Evans services coordinated into the apartment plan

Unpublished G2-P2 proposal. User review required before adoption; published v67 and Google Flow v66 stay unchanged.

Replace the 18 earlier nominal wet-room boxes with eight continuous wet-stack groups and two dry risers. Keep separate wet and electrical rooms, fit two 3-bedroom homes with studies, and provide refuse/recycling storage at the rear alley.

EV-G2-P2 · UNPUBLISHED · Engineering and accessibility approval remain open

Native ground-floor cutaway

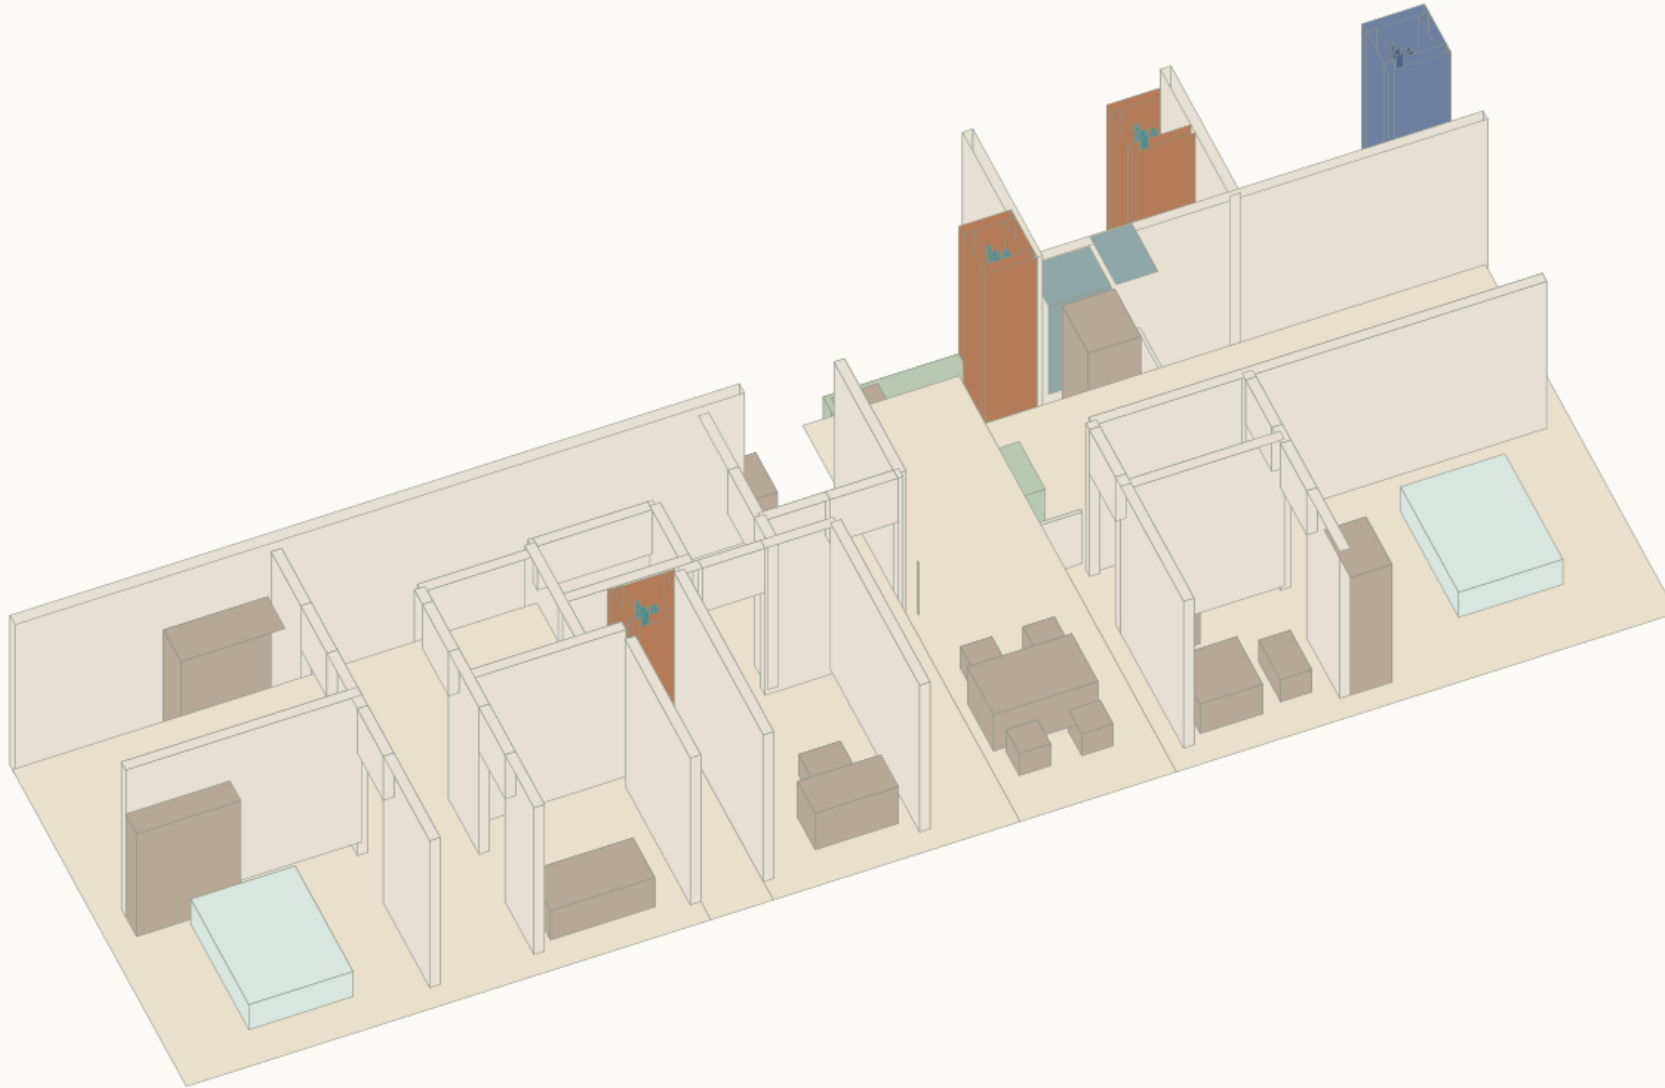
Building A. Exterior shell and upper floors hidden for inspection; shafts clipped at 10.2 ft in this view only.

Doors are voids in extruded partitions. Ochre shafts are wet; the blue shaft is the separate dry riser.
